Millstone Nuclear Power Station, Unit No. 3
Reporting of Potential Significant Deficiencies in Design
and Construction: Westinghouse 7300 Process Protection
System - Potential Problems with NTC Card Relays (SD-39)

S.O. No: NEU-320
NEU-7.35.31Mr. S. Orefice
Project Engineer
NORTHEAST UTILITIES SERVICE COMPANY
P.O. Box 270
Hartford, Connecticut 06141NORTHEAST UTILITIES SERVICE COMPANY
MILLSTONE NUCLEAR POWER STATION
UNIT NO. 3
7300 Process Protection System Potential Problems
With NLP Card Heat Sinks and NTC Card Relays

NS-EPR-2774

Dwg. 403A947

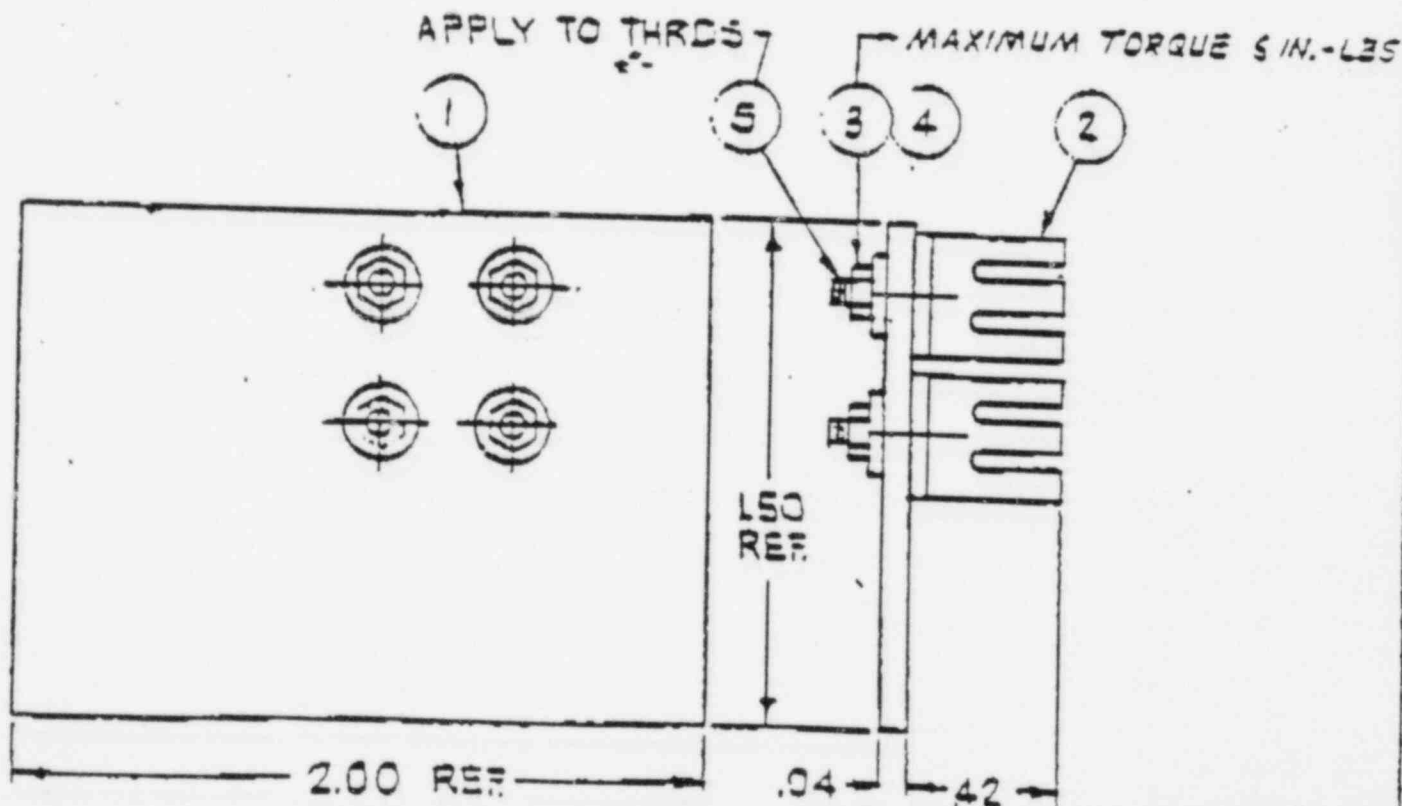
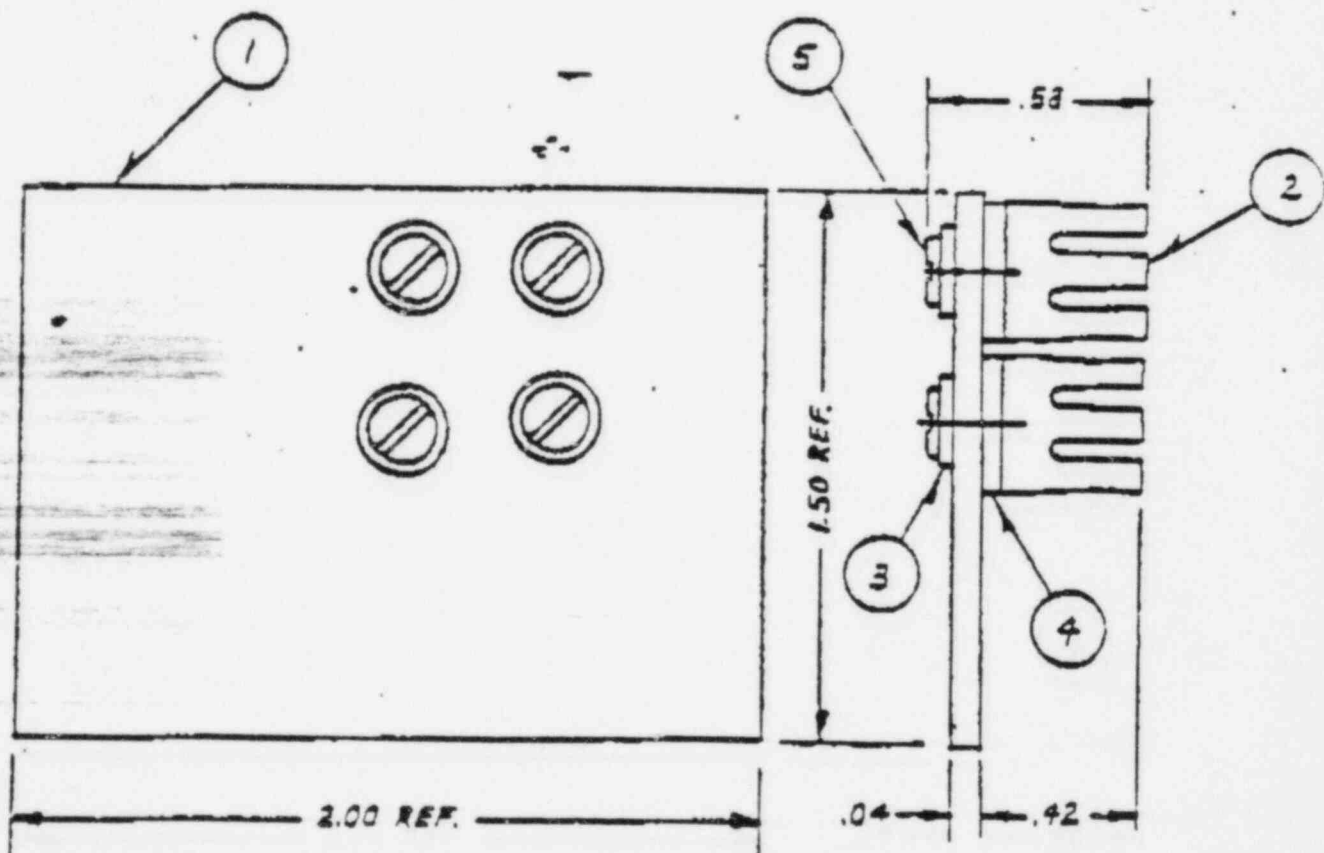
Westinghouse has committed to provide replacements for the heat sinks that are subject to this potential adhesive failure mechanism. These heat sinks can be identified by inspection of the printed circuit card for hex nuts visible on the top side of the assembly. See attached drawing 404A605 (superseded) (Attachment 1). The new style heat sink has screw heads visible from the top side of the assembly (see Drawing 403A947 Attachment 2).

SUPERSEDED BY
 NOTE: DWG. 403A947G01 FOR OLD
 OR NEW DESIGN.

1-TO RETROFIT TO EXISTING P.C. BOARD ASSEMBLIES, MOUNT THERMAL LINK IT.2 TO TRANSISTORS BEFORE ASSEMBLING TO HEAT SINK PLATE IT.1.
